Proposed Mundijong Precincts E1 & E2 Local Structure Plan - Schedule of Modifications

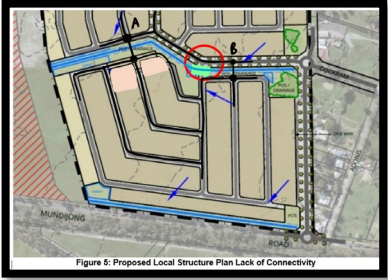
13.	LSP Part 1 Section 6.2	Remove dot point c.	Notifications on certificates of title are not required to advise of Local Development Plans.
14.	LSP Part 2 Section 3.7	<p>Add a statement to Section 3.7 stating the below:</p> <p><i>"If, during construction Aboriginal artefacts or sites are uncovered, that these are protected under the Aboriginal Heritage Act 1972 and that works will need to cease and suitably qualified experts will be brought in to survey the potential site, and if required permission under the Aboriginal Heritage Act 1972 to manage and disturb sites will be sought".</i></p>	The LSP acknowledges heritage sites overlapping with the western portion of the site, however these are classified as 'data stored/not sites'. The Environmental Assessment Report states that there is potential for future Aboriginal heritage sites to be found during works. The LSP should reflect the measures to account for this.

Figure 10: Public Open Space Plan

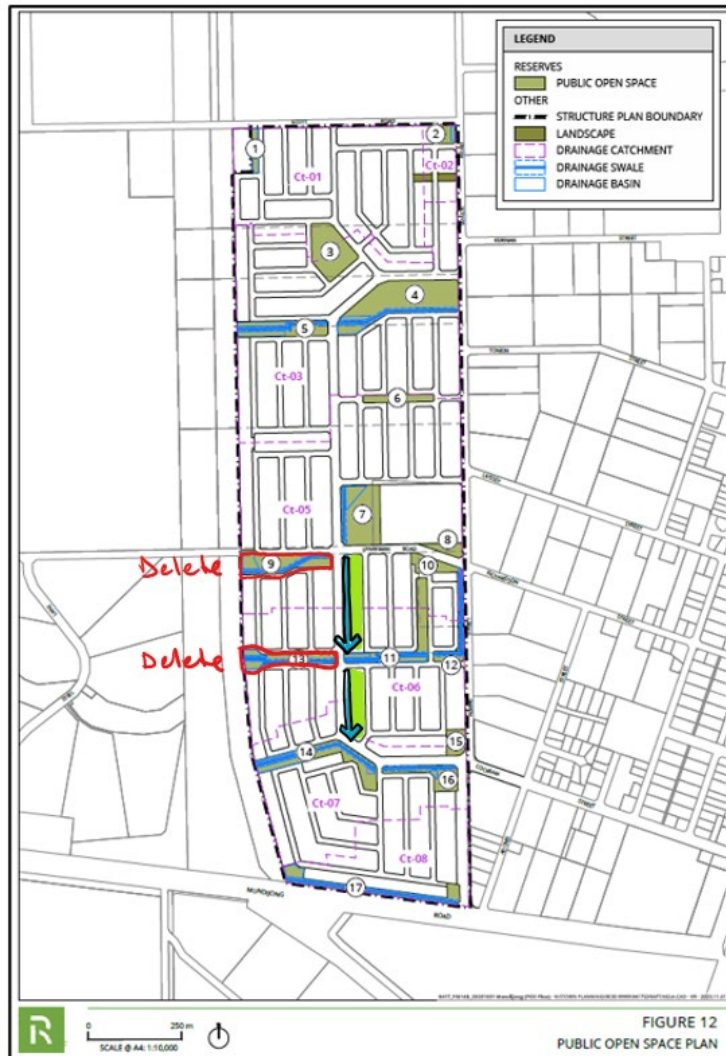
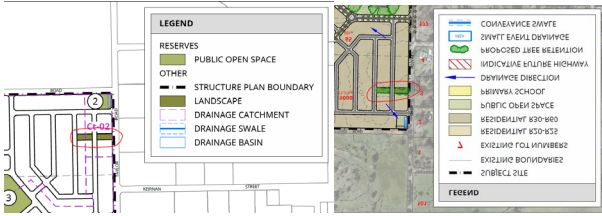
31.	LSP Part 2 Section 4.3, and appendices	Reconfigure the POS to reduce the number of narrow, linear and restricted drainage-based POS, and incorporate an increased proportion of usable POS. Reduce the number of Multiple Use Corridors from five to three as shown below, ensuring that the 10% POS provision can be achieved across the LSP site.	The significant majority of POS is proposed to serve a drainage function, as narrow, linear drainage corridors and there is a lack of usable open spaces. This places high pressure on the NPOS for active recreation. The distribution of POS should more appropriately balance drainage and usable POS. This will reduce the amount of land consumed by MUCs and to also reduce the maintenance burden that these would otherwise create.

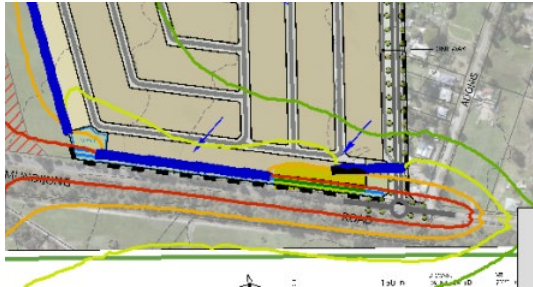
56.	LSP Part 2 Section 4.7	Remove reference to the soakwell and subsoil drainage strategy proposed within private lots, including the 'shared soakage structures' strategy.	Shire officers do not support subsoils within private lots. Due to the site's clayey soils, low infiltration rate and high
